UNITED STATES PATENT AND TRADEMARK OFFICE

APPLICATION NO.	FILING DATE	FIRST NAMED INVENTOR	ATTORNEY DOCKET NO.	CONFIRMATION NO.
10/737,019	12/16/2003	Charles M. Mettler	PSSIP0115US	5594

Office Action Summary

This is the second non-final Office Action for application number 10/370,019 Base Support for Post or Other Upright, filed on 12/16/03. Claims 1-9, 11-20, 22-36 are pending. This non-final Office Action is in response to applicant's reply dated 1/24/05. The text of those sections of Title 35, U.S. Code not included in this action can be found in a prior Office action.

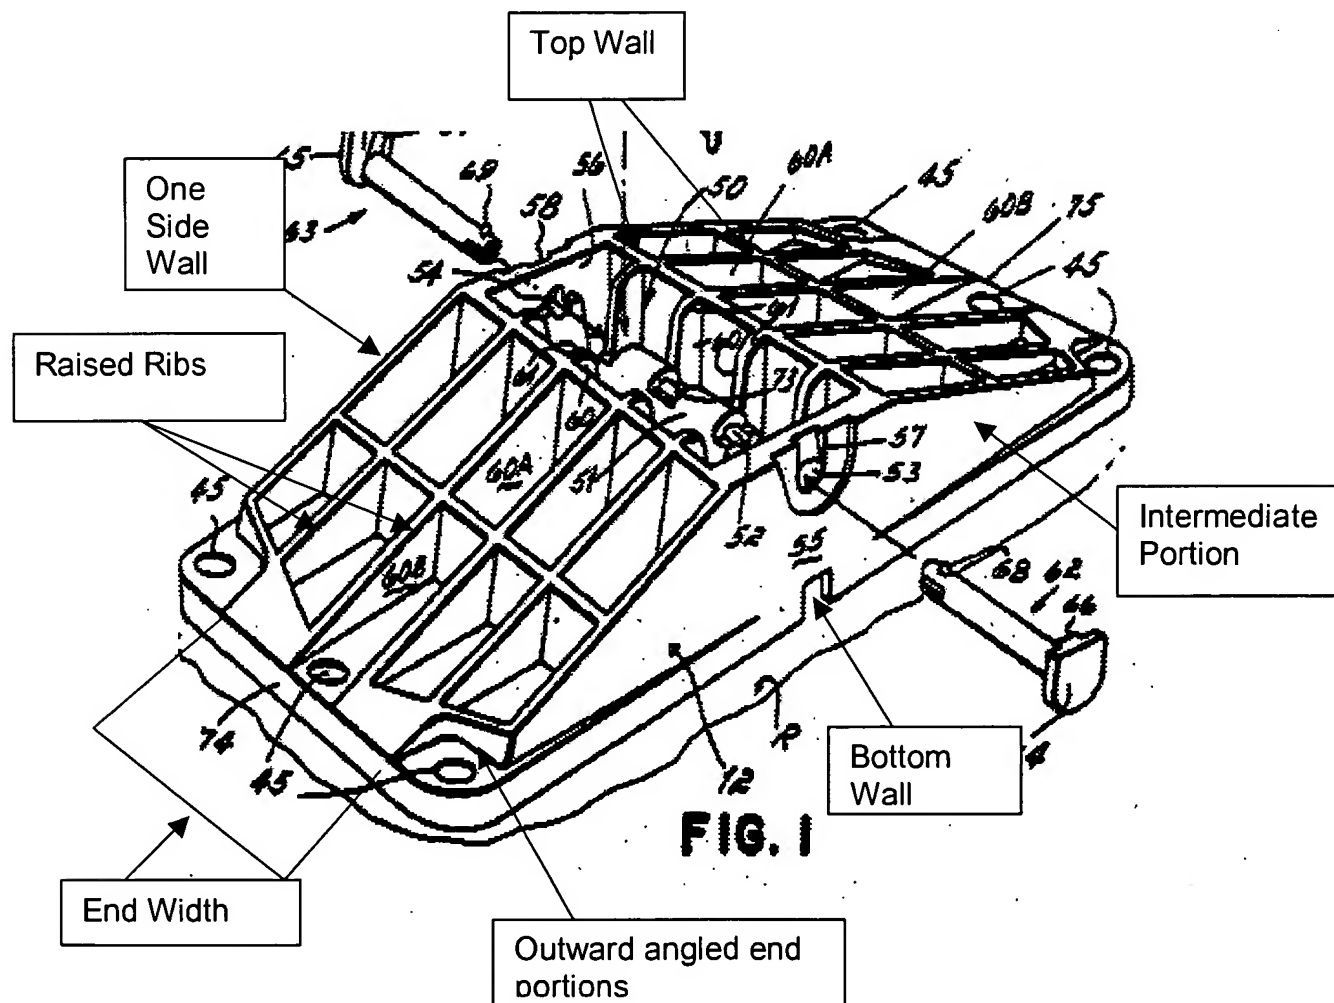
The patent to Mariol et al. teaches a molded plastic base support (See Col. 4 lines 39-45 and Col. 5, line 53, for material) for supporting an elongated member in a substantially upright position having a base member (10) having a greater length than width and spaced apart bottom and top walls and opposite side walls (55), one of the side walls being substantially straight and in substantially the same plane throughout its length, and the other of the side walls having an intermediate length that is spaced further from the plane of the one side wall than end lengths of the other side wall to provide the base member with a wider intermediate width than end widths, and a non-circular cross-sectional shaped mounting hole (50) extending through the top wall in the wider intermediate width, the mounting hole having a width greater than the end widths and less than the intermediate width of the base member, wherein the end walls are in substantial alignment with each other in a parallel spaced relation from the one side wall

and the mounting hole has a center that extends in a direction substantially perpendicular to the top wall and is substantially in the same plane as the end lengths of the other sides wall. There is a horizontal plane that passes through the mounting hole center and through all the end lengths. Mariol et al. also discloses wherein the intermediate length of the other side wall has outwardly angled end portions extending toward each other and an intermediate portion extending between the end portions in parallel spaced relation to one side wall.

Mariol et al. also discloses wherein the mounting hole has a plurality of laterally spaced longitudinally extending ribs (60) around the entire periphery of the mounting hole that are axially transversely rounded and wherein the top wall has a plurality of axially spaced apart stacking ribs (See Drawing Above) and the bottom wall has corresponding recesses (89, 90) for receipt of the stacking ribs.

Mariol et al. and Stagl et al. teach the basic inventive concept including wherein Mariol et all. teaches wherein the base member has thinned out non-hollow solid end portions and wherein the top wall of the ends portions has raised ribs (See Drawing

The applicant has argued that the reference to Mariol et al. does not teach a base support which has substantially straight and in substantially the same plane throughout its length and the other has an intermediate length spaced further from the plane of to one side wall than end lengths of the other side wall. This is unpersuasive as shown by the marked drawing above.
